PLAN OF BUILDING

ON PLOT No 6/1 SHEET FIS SUDDER BAZAR Q8

*A amended plan
of Building on plot No 6/1 sheet
Sudder Bazar Quarter
Scale 8=1"*

*Amended plan
of Building on plot- No 6, Sheet F 15
Subber Bazar Quarter
Scale 8"=1"*

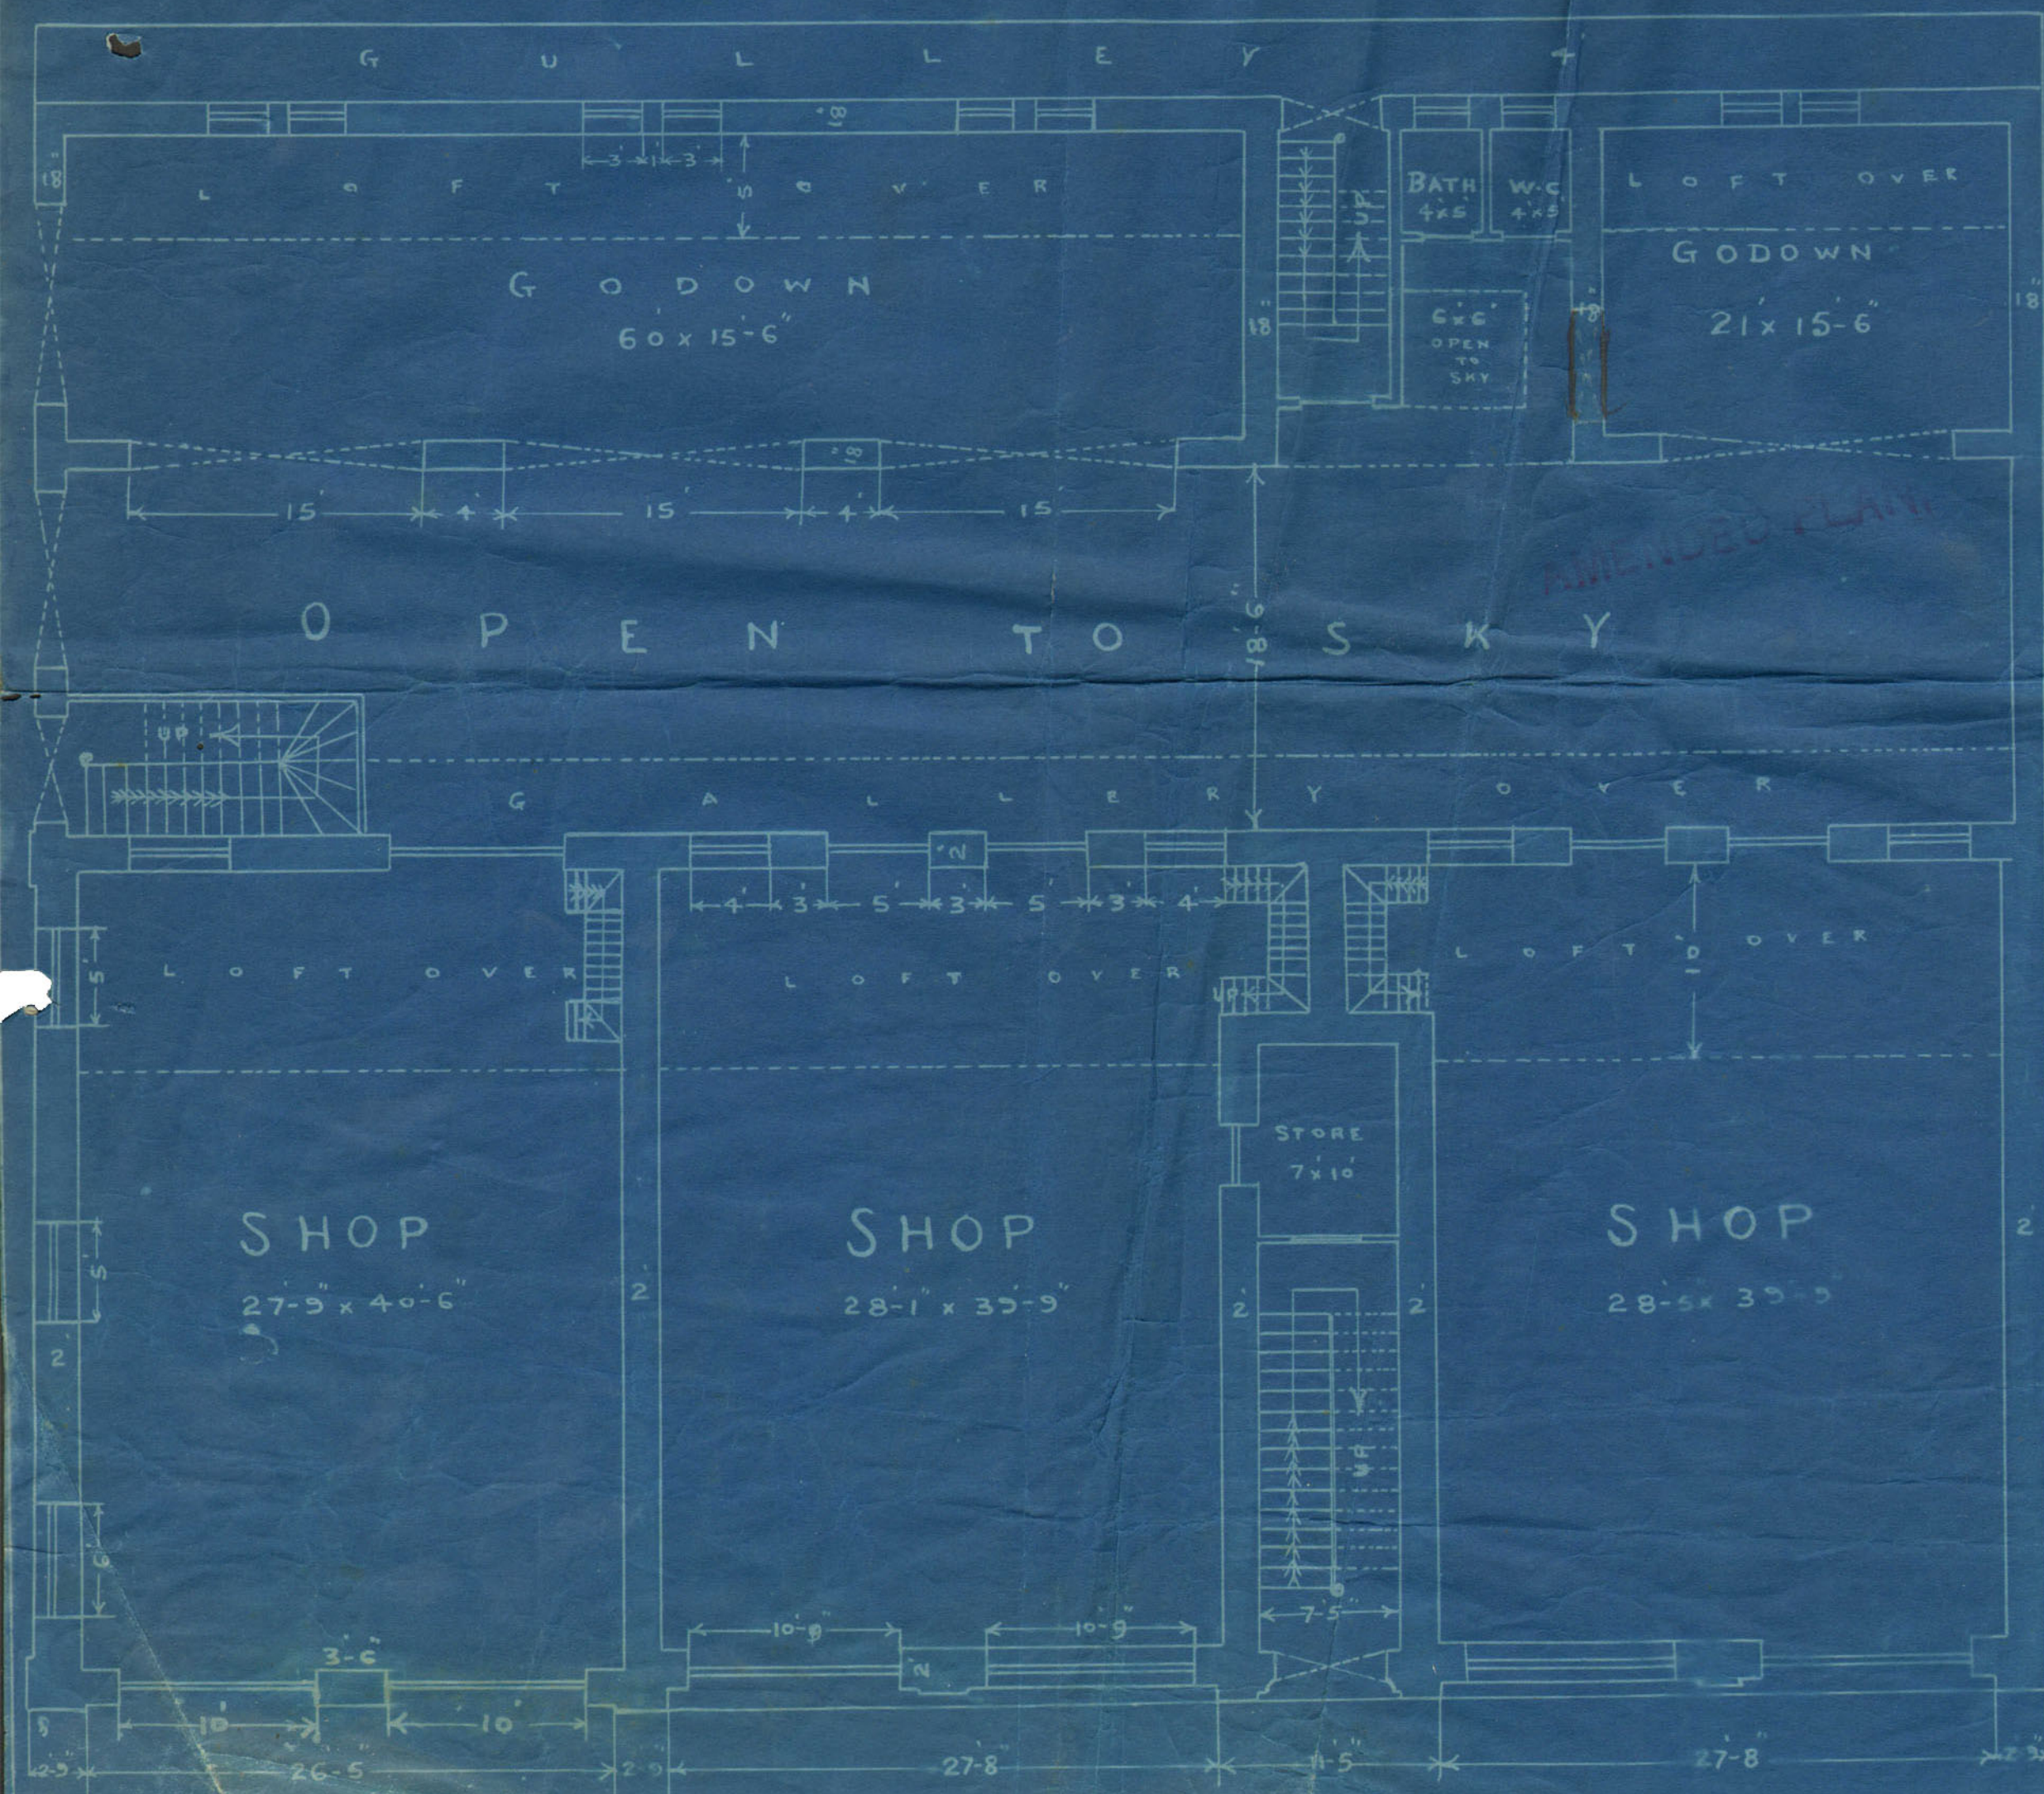
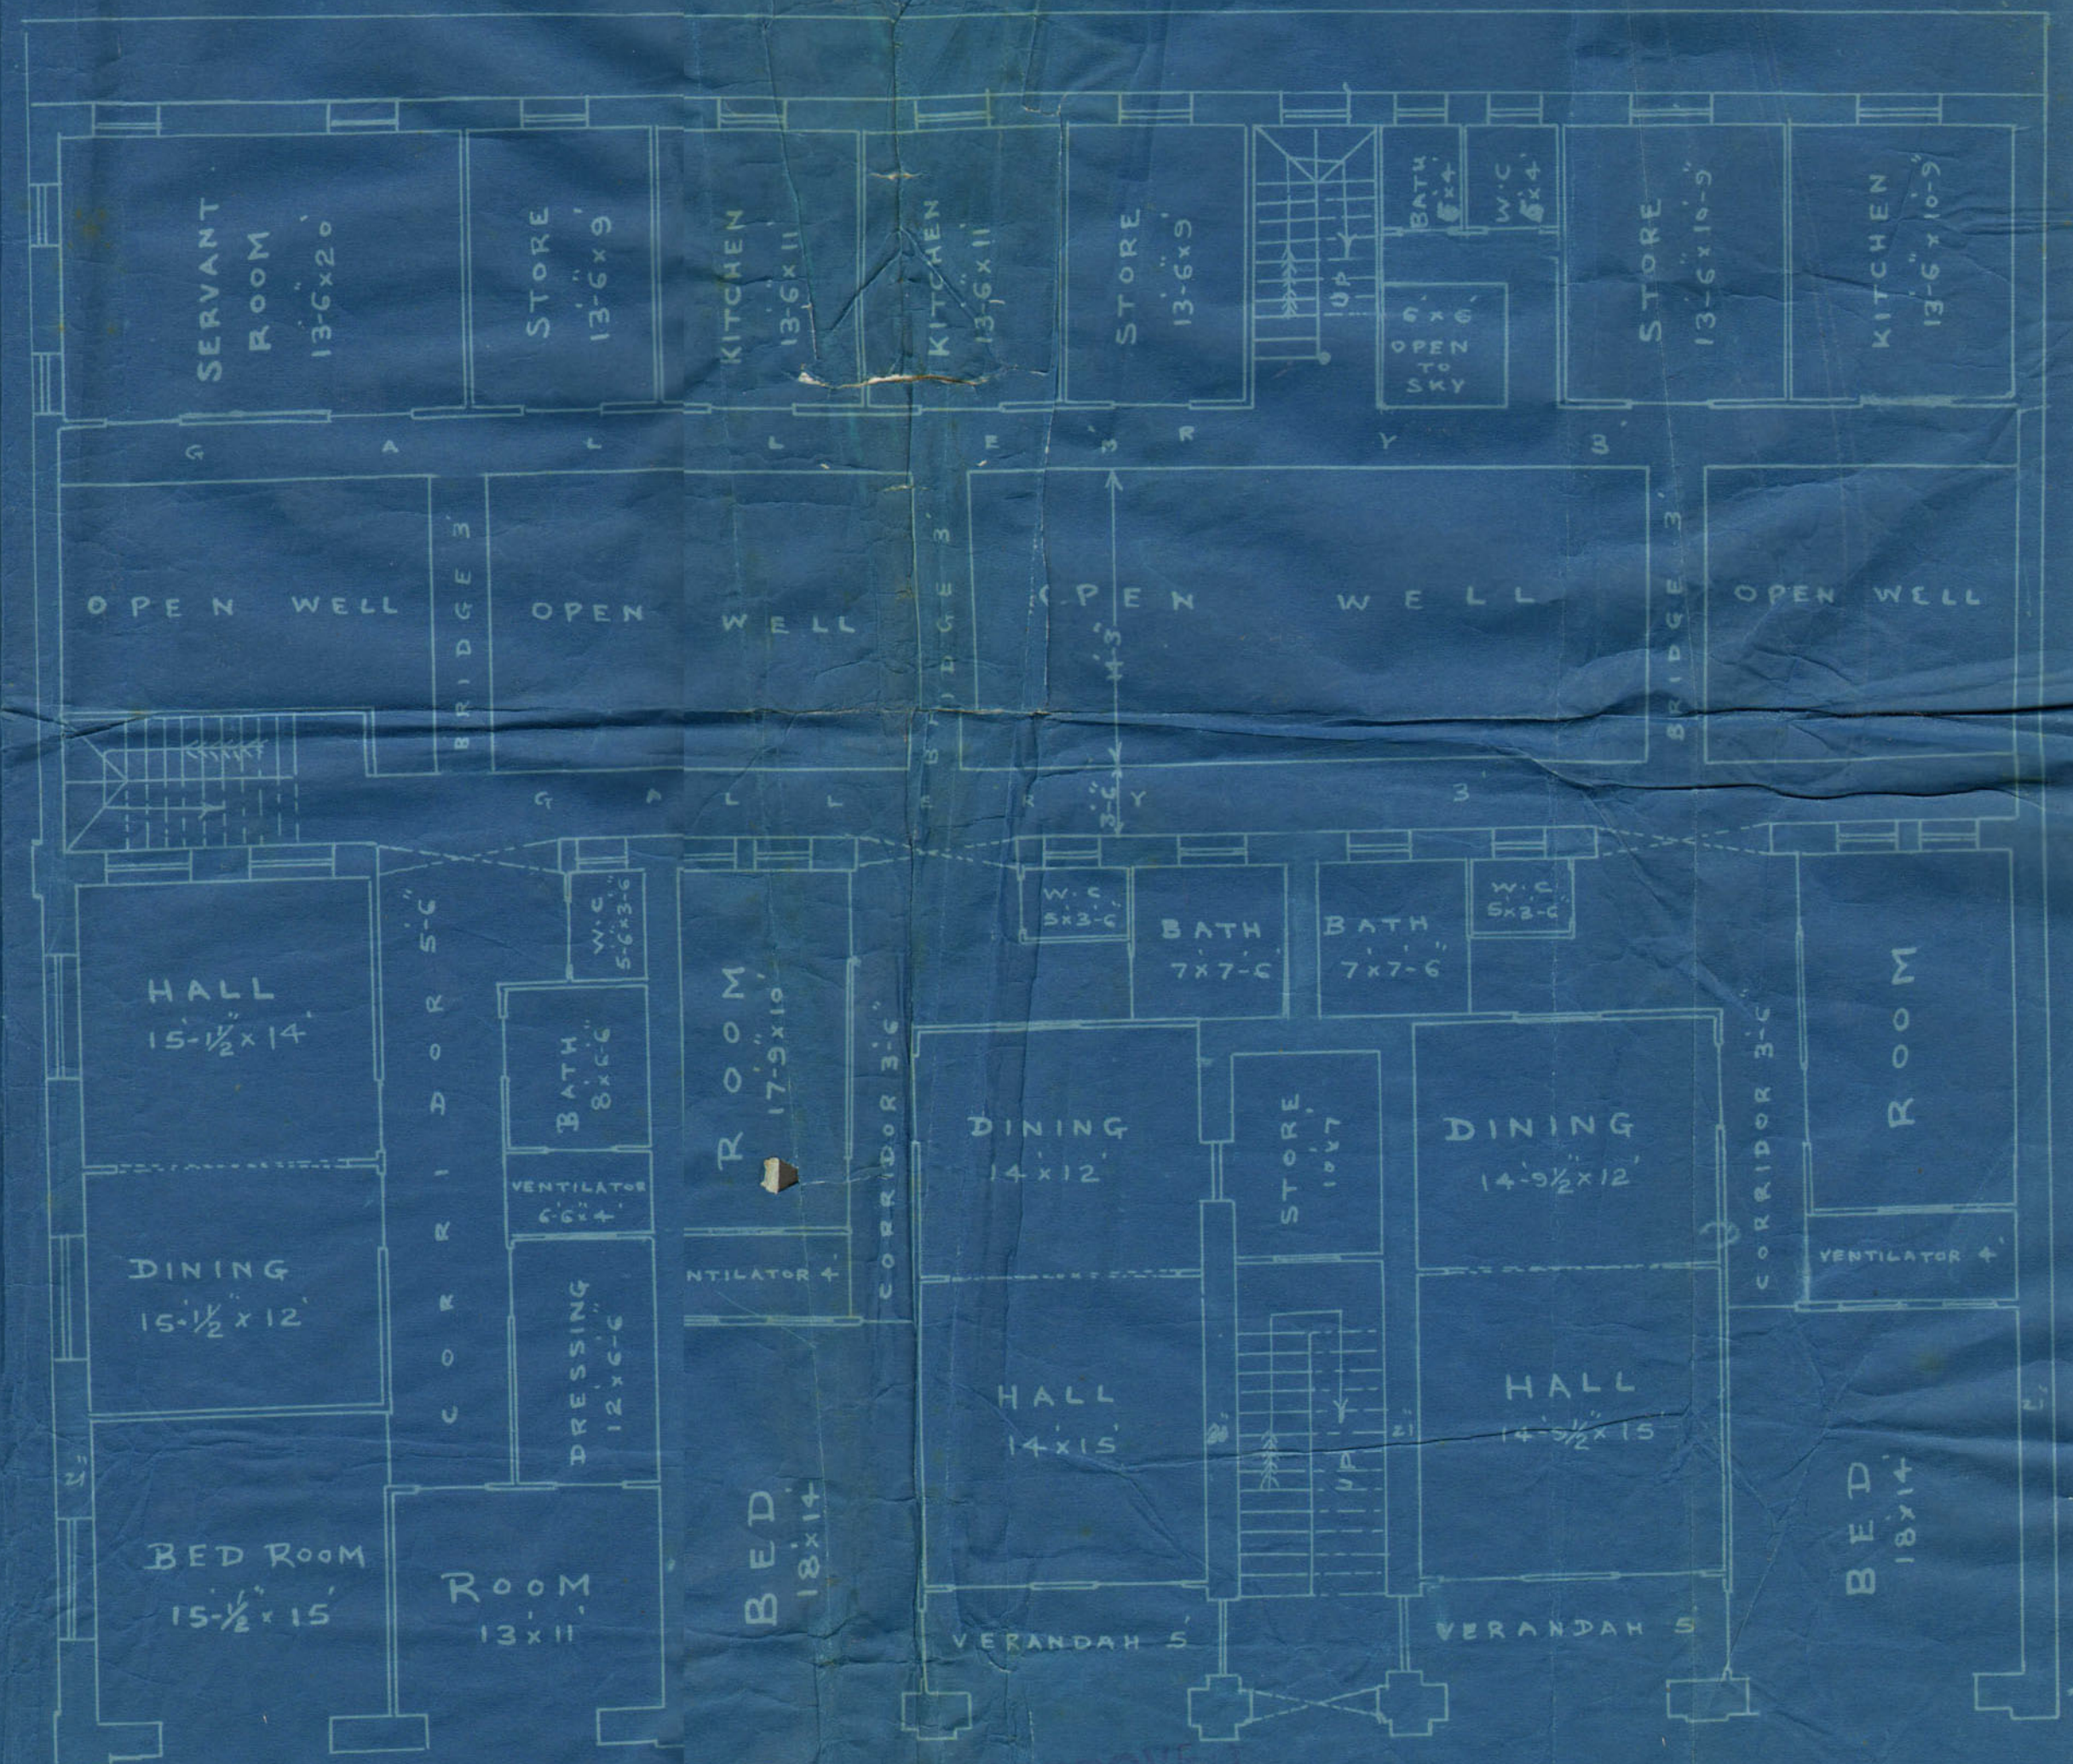
With respect to
 this I beg to report -
 that there is / no
 objection to the
 plan as submitted
 but there is only one
 servants Rm provided
 between three tenements
 in place of two already
 shown in approved plan. R.O.
 Your obdtly.
 J.S. Jagan.
 P.S.A.

Submitted to the Engrs
 for order. order was
 should be of stone
 & more servants Rm
 required.

Insufficient servants
 quarters

With reference to his application with ^{consent} plan received on 14/7/19. re bldg on plot No 6/1, P₁₅-Saddan Qtr. Mr Shamdas Kodummal is informed, that the plan as submitted is approved and a copy of it is herewith forwarded to ^{him} ~~them~~ duly signed & approved to build according to the plan

With reference to his application with amended plan received on 14th July 1919 regarding building on plot No. 6/1, F-15 Sadar Bazar Quarter Mr. Shamdas Kodanmal is informed the plan as submitted is approved and a copy of it is herewith forwarded to him duly signed and approved to build according to the plan.
